**PLANNED UNIT DEVELOPMENT
STAFF REPORT****Date: September 6, 2012****DEVELOPMENT NAME**

Chinnis Holdings LLC

LOCATION5401 Cottage Hill Road
(Southwest corner of Cottage Hill Road and Vivian Drive)**CITY COUNCIL
DISTRICT**

Planned Unit Development Approval to amend a previously approved Planned Unit Development to allow shared access between two building sites to include an 8' X 20' trailer.

SITE PLAN

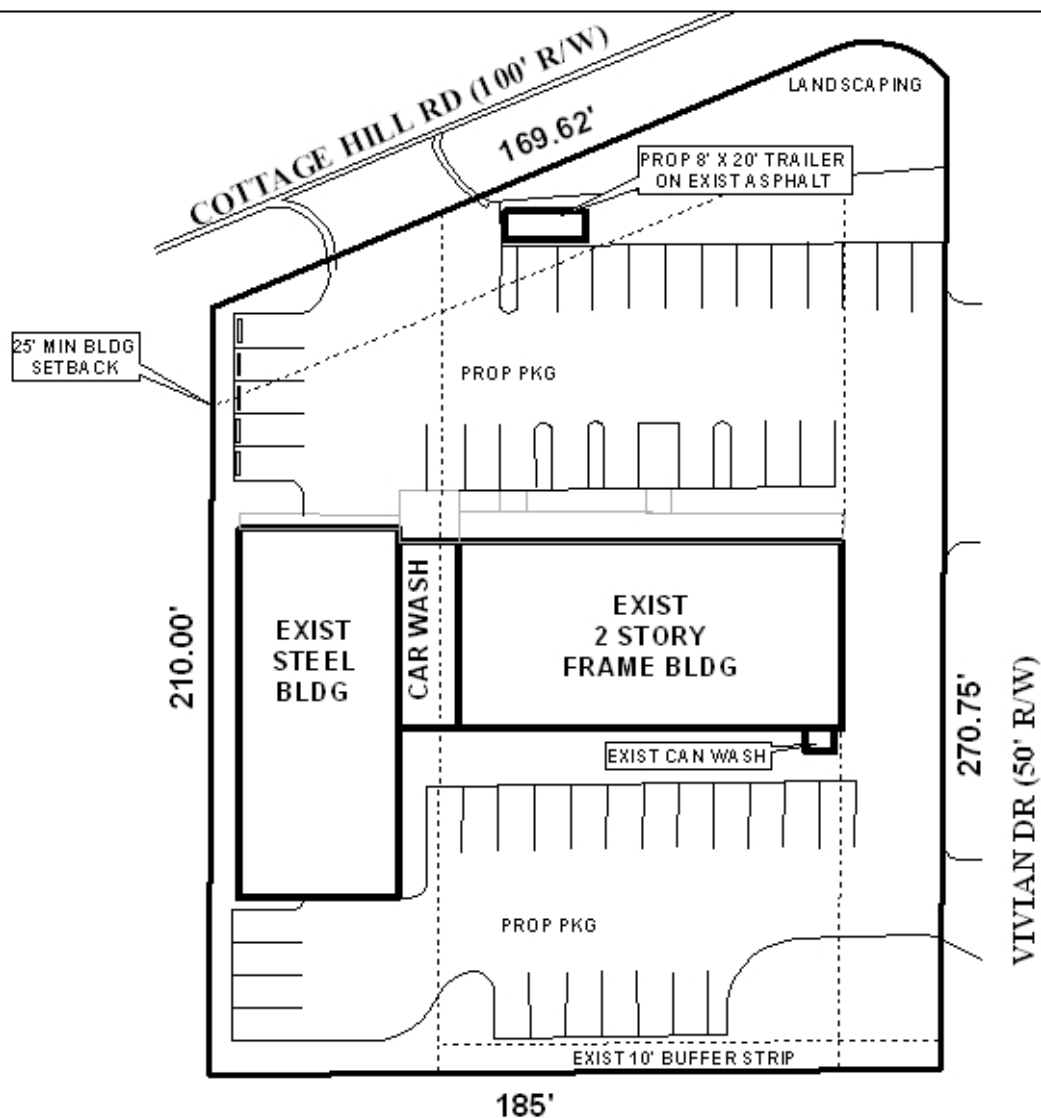
The parking layout along Cottage Hill Rd should be illustrated in a straight line parallel with the building and driving aisle, and not parallel with the roadway right-of-way. As illustrated the first space nearest the Cottage Hill Rd driveway is non-standard length, and the three spaces nearest the Vivian Dr driveway require excessive backing to exit the spaces. As noted, the driveway size, location and design are to be approved by Traffic Engineering and conform to AASHTO standards. Driveway radii are not shown; a 20' radius is

typical for passenger cars and a 30' radius is desirable for large trucks. The site plan does not include sidewalk along either roadway frontage.

The proposed location of the barbecue trailer results in a modified front parking area that creates parking spaces of various alignments. As commented by Traffic Engineering, the parking spaces facing Cottage Hill Road should be realigned to be parallel to the parking spaces facing the building, providing a uniform row of parking. Also, the trailer itself should not be placed on an unpaved area. The site plan should be revised to realign the parking and depict the trailer on an asphalt or concrete surface.

It appears that a dumpster is proposed to be located within the building setback line along Vivian Drive, in a landscape area. Dumpsters must meet all required building setbacks and must be enclosed on three sides by a fence or wall, located on a dumpster pad, and be situated so that servicing of the dumpster occurs entirely on private property. Furthermore, all dumpsters must now be connected to the sanitary sewer system and include a grease trap. The site plan should be revised to show the dumpster relocated to meet all setbacks, be serviceable by a truck completely on private property, and to have a connection via a grease trap to the sanitary sewer.

The site plan includes the area dedicated to the City of Mobile for the Vivian Drive right-of-way. The site plan should no longer include any dedicated land as part of the site, and instead this area should now just be a part of the right-of-way for Vivian Drive, with the right-of-way width revised to reflect the dedication.

It is apparent that vehicles are parking in landscape areas. Provisions should be shown on the site plan to prevent vehicles from maneuvering in landscape areas, including the provision of curbs or parking bumpers.

Landscape areas are shown on the site plan, but no quantitative information is provided regarding how much landscape area is provided. The site plan should include total landscape area in square feet, and total frontage landscape area in square feet. Urban Forestry has additionally requested compliance with the frontage tree requirements of the Zoning Ordinance. Therefore the site plan should be revised to depict frontage tree compliance, and should depict any existing trees within the frontage area that will remain and be claimed for credit.

Finally, the site plan depicts three proposed handicap accessible parking spaces. The Americans with Disabilities Act requires at least one of the spaces to be van accessible, and requires all spaces to be properly signed. None of the proposed spaces appear to meet van accessibility requirements, and their location does not appear to be near any ramp that allows clear access into the tenant spaces. The site plan should be revised to comply with all applicable federal laws regarding handicap accessibility, as Planned Unit Development approval is site plan specific, and any redesign of the parking area will change the site plan.

As shown on the site plan, the trailer will be parked in the 25-foot setback along Cottage Hill Road. It is recommended that the applicant shift the location of the trailer to meet the 25-foot setback from both Cottage Hill Road and Vivian Drive, and it appears that there will be adequate space for the shift.

A representative of Traffic Engineering visited the site and observed that the auto repair tenant is parking vehicles on landscape areas in the right-of-way of Cottage Hill Road, and in such a manner as to partially block entry to the site from Cottage Hill Road. They also commented on the fact that the 10-foot shift in parking, as proposed, will partially complicate exiting the site at the Cottage Hill Road driveway.

Due to Traffic Engineering observations, the applicant may wish to remove one parking space at the Western end of the relocated parking to allow for smoother traffic flow at the Cottage Hill entry, and may wish to delineate with striping the 24-foot wide access aisle and paint "no parking" in the aisle to ensure that the auto repair tenant does not block entry/exit of the site at the Cottage Hill Road curb-cut.

- 2) Revision of the site plan to reflect Traffic Engineering comments (*remove one parking space at the Western end of the relocated parking to allow for smoother traffic flow at the Cottage Hill entry, and delineate with striping the 24-foot wide access aisle and paint “no parking” in the aisle to ensure that the auto repair tenant does not block entry/exit of the site at the Cottage Hill Road curb-cut*);

- 3) Revision of the site plan to relocate the trailer to meet 25-foot setbacks from Cottage Hill Road and Vivian Drive;
- 4) Elimination of all parking in landscape areas in the Cottage Hill Road right-of-way;
